ADDENDUM #2

CITRUS WAY CULVERT IMPROVEMENTS

HERNANDO COUNTY, FLORIDA

CEO # SOLICITATION NO. 10-0086

BAILEY HILL RD CULVERT REPLACEMENT
 PLAN SHEET

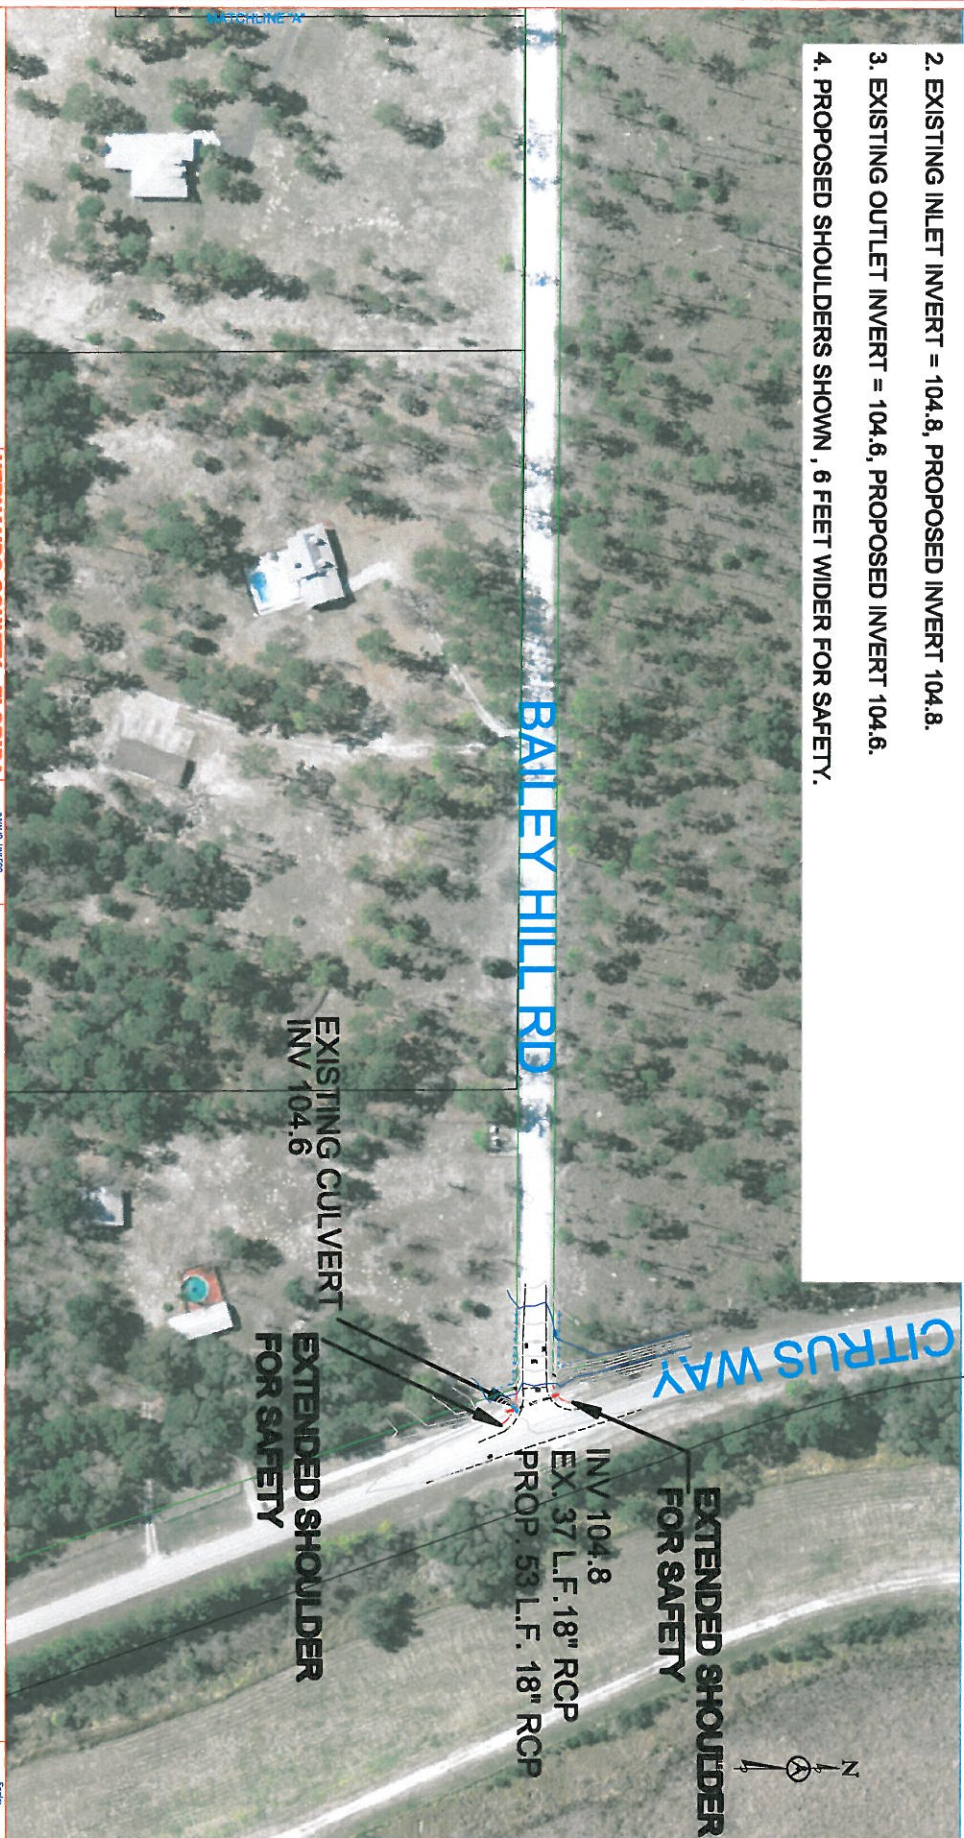
1. Add plan sheet for culvert replacement at Bailey Hill & Citrus Way.

- 1. REPLACE EXISTING CULVERT 37 L.F. WITH PIPE OF SAME DIAMETER, 53 L.F., 6' LONGER ON EACH END.
- 2. EXISTING INLET INVERT = 104.8, PROPOSED INVERT 104.8.
- 3. EXISTING OUTLET INVERT = 104.6, PROPOSED INVERT 104.6.
- 4. PROPOSED SHOULDERS SHOWN, 6 FEET WIDER FOR SAFETY.
